Subject: Technical Specification Change Request No. 291 – Safety Limit Minimum Critical Power Ratio

Oyster Creek Generating Station  
Facility Operating License No. DPR-16  
NRC Docket No. 50-219

**Oyster Creek Technical Specification Change Request No. 291**

**Markup of Proposed Technical Specification Page Changes**

Figure 2 Reference Core Loading Pattern – Cycle 19

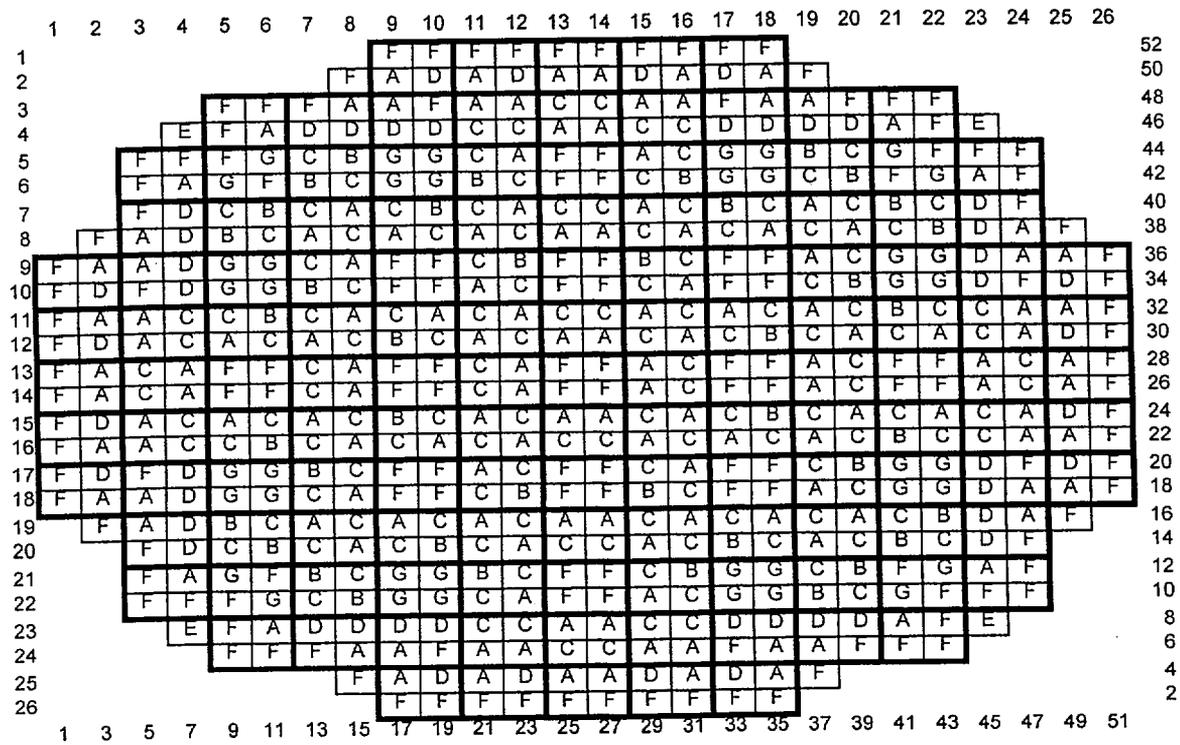
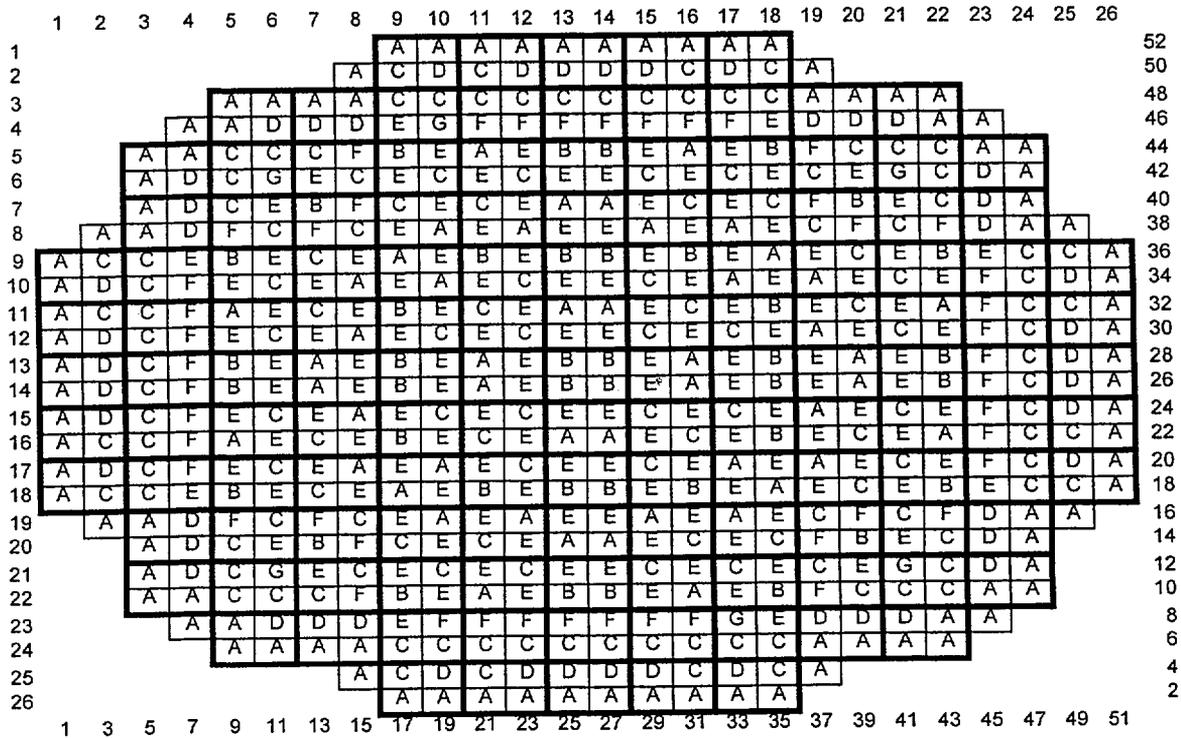
The core loading information for Oyster Creek Cycles 18 and 19 is provided in Figures 1 and 2, respectively. The impact of the fuel loading pattern differences on the calculated SLMCPR is correlated to the values of [[ ]]
